- Board of Directors
Engineering and Operations Committee

7/14/2020 Board Meeting

Review and consider Addendum No. 1 to the 2015 Mitigated Negative Declaration, and award a \$3,270,000 contract to Kiewit Infrastructure West Co. to reline pipe and replace pipefittings at the Lake Perris Control Facility and on the Lakeview Pipeline

The purpose of this Addendum is to evaluate potential environmental effects associated with minor technical modifications to the previously approved Lakeview Pipeline Repair Project (Original Project). An Initial Study – Mitigated Negative Declaration (IS-MND) for the Original Project was adopted by The Metropolitan Water District of Southern California (Metropolitan) in 2015 as part of its approval of the Original Project (State Clearinghouse [SCH] #2015061016).

Figure 4 Proposed Modifications – Lake Perris Pressure Control Facility

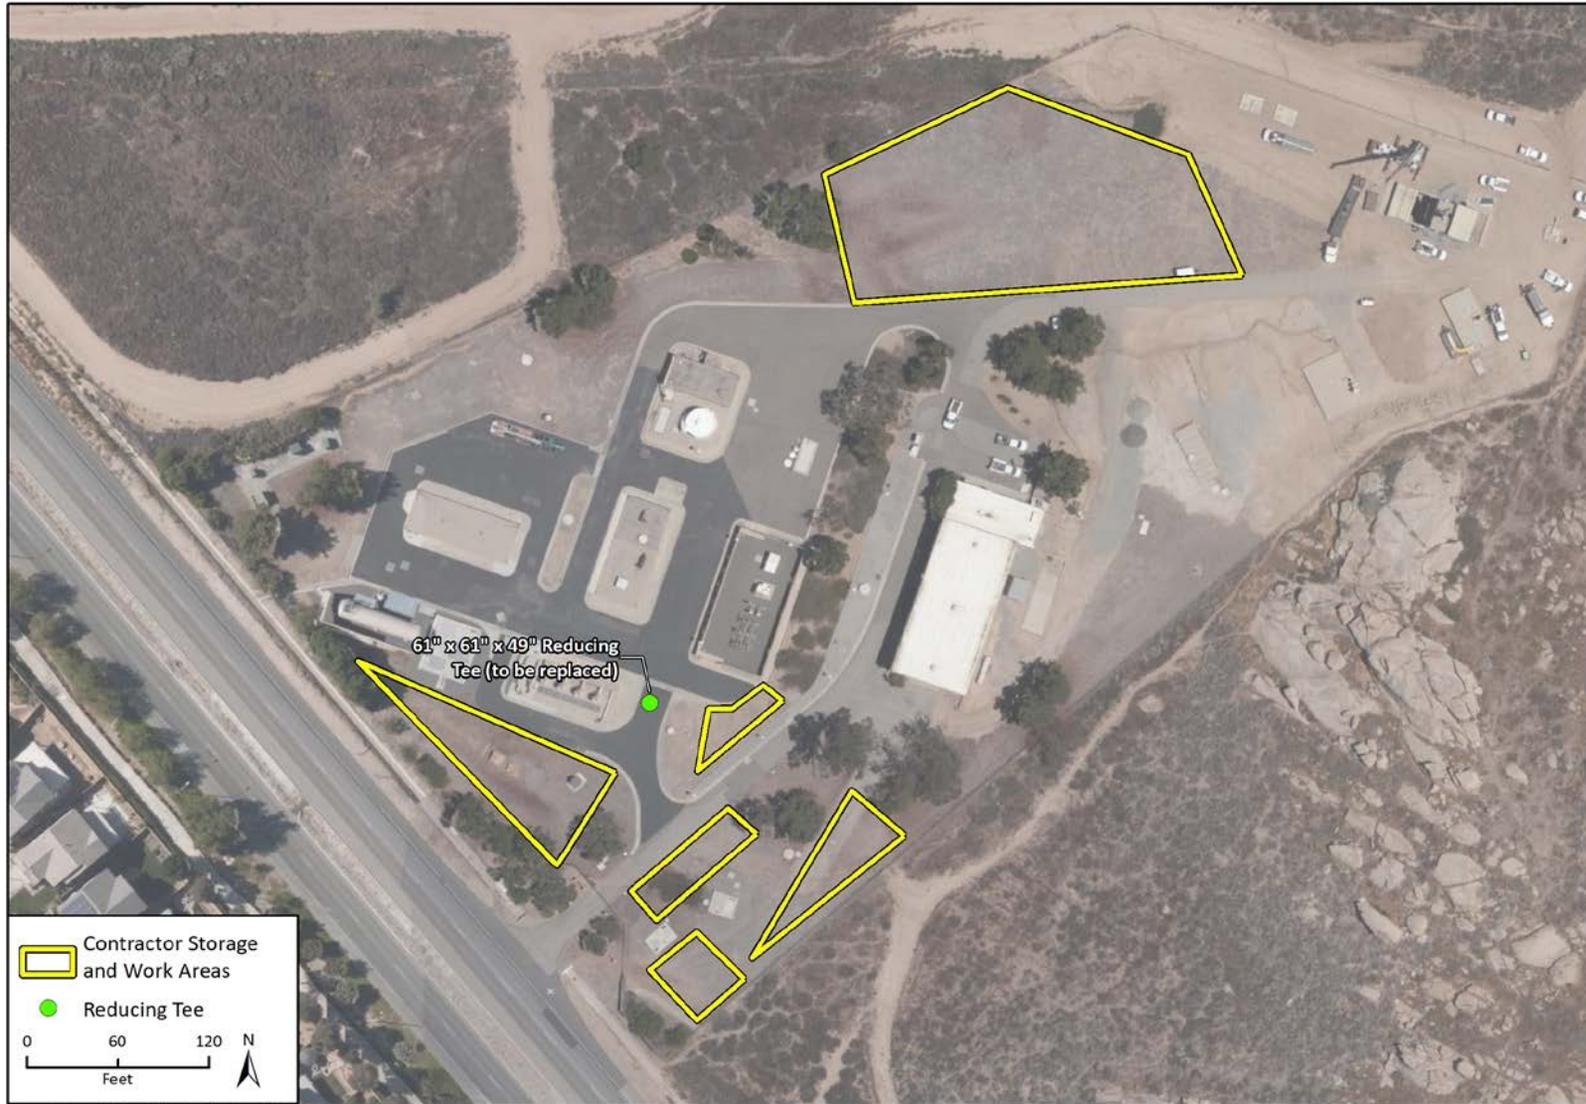
The Modified Project would involve replacement of an existing 61-inch by 61-inch by 49-inch reducing tee within the Lake Perris Pressure Control Facility. The replacement would involve sawing and cutting of existing asphalt, excavation of an approximately 400-square-foot area to a depth of approximately 18 feet, replacement of the existing reducing tee, pouring of concrete to encase the new reducing tee, and backfilling and repaving of the excavated area. It is anticipated that replacement of the reducing tee would involve excavation of approximately 200 cy of soil. Excavated soil would be used for backfill as feasible; approximately 20 cy of remaining soil would either be spread or stored at the Lake Perris Pressure Control Facility or exported off site.

Figure 4 shows the Lake Perris Pressure Control Facility and location of the reducing tee and contractor work and storage areas.
